Subject: Byron Station Units 1 and 2
Braidwood Station Units 1 and 2
Safety-Related D.C. System
Additional Information
NRC Docket Nos. 50-454/455 and 50-456/457

ATTACHMENT A
RESPONSE TO REQUEST FOR ADDITIONAL INFORMATION
SYSTEM-RELATED DC SYSTEM
BYRON/BRAIDWOOD STATIONS, UNITS 1 AND 2

Figure 1

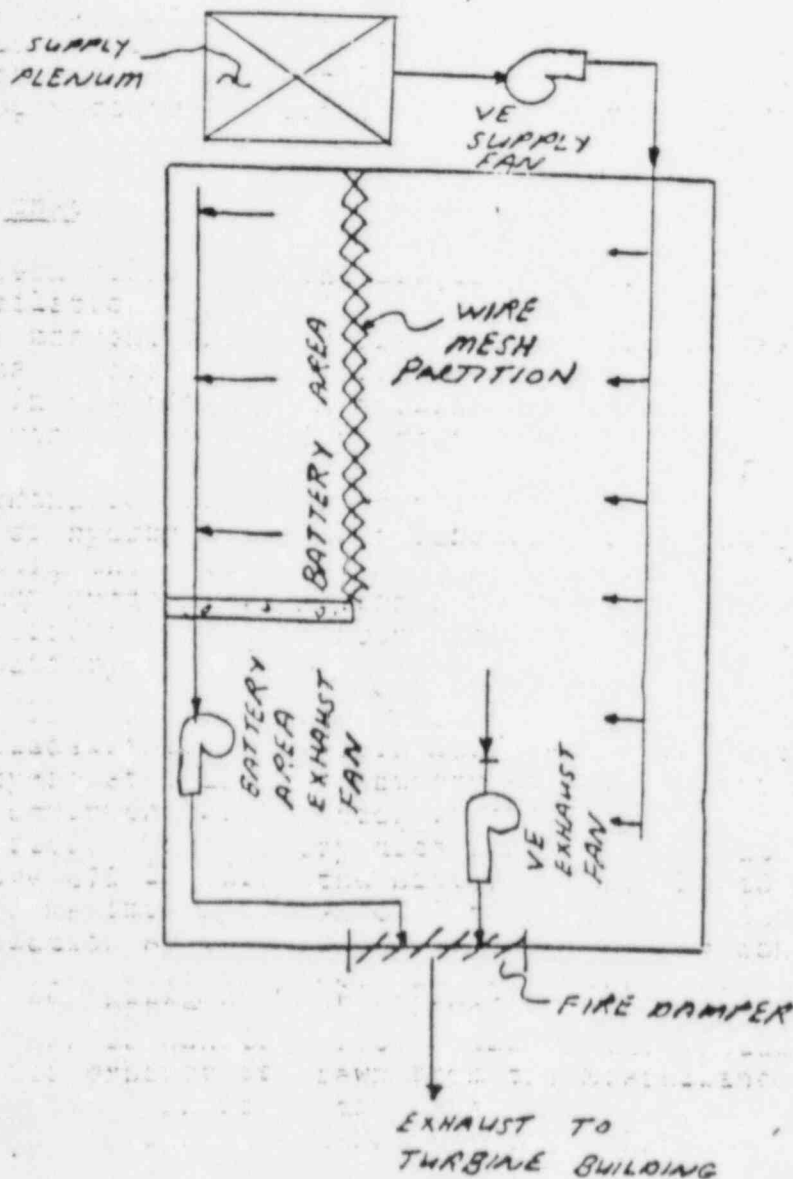
We note that in Amendment 2 to the Fire Protection Report Figure 2.3-8 Sheet 1, the applicant removed the wall between the redundant 125 volt safety-related battery divisions and other equipment in the miscellaneous electrical equipment rooms and replaced the wall with a wire fence. The present ventilation system for the battery area may not be adequate to remove hydrogen accumulation resulting from battery charging because of the much greater area now served by the ventilation exhaust system and because the new area may contain some dead spaces at the ceiling. Therefore, the applicant shall demonstrate through analysis and/or testing that the present ventilation system, including the air supply and exhaust fans in the battery area, will maintain sufficient continuous ventilation of the battery areas to limit the hydrogen concentration to 2%, as previously stated in the FSAR.

The determination of the amount of ventilation required for dilution of hydrogen gas is a function of the amount of hydrogen evolved from the batteries, and is not a function of the volume of the room. The maximum hydrogen evolution rate was based on a "runaway" charger forcing its rated output current through the fully charged battery.

Figure 1 illustrates the equipment arrangement and air flow for the Miscellaneous Electric Equipment Room ventilation system. The safety-related 125V DC Battery Area is a part of the Miscellaneous Electric Equipment Room, which is enclosed by a three-hour fire-rated barrier. The battery area exhaust ventilation system will remove 475 CFM from the battery area.

All of the makeup air for the battery area exhaust is drawn from the Miscellaneous Electric Equipment Room. In order to purge (i.e., sweep) the total volume of the battery area, the exhaust duct is located adjacent to the wall opposite the wire mesh partition. The exhaust ductwork is located at the highest practical point in the room (i.e., immediately under the intermediate roof structural steel) and extends over the entire length of the rear battery rack.

Based on the calculated maximum hydrogen evolution rate (as defined above), the ventilation system will limit the hydrogen concentration in the battery area to 1.44%; 28% less than the "2% of the total volume of the battery area" allowed by IEEE Standard 484-1981. Even if it is assumed that a fraction of the hydrogen gas (say 30%) escapes to the Miscellaneous Electric Equipment Room, the maximum concentration of hydrogen in either room is 1.44%.
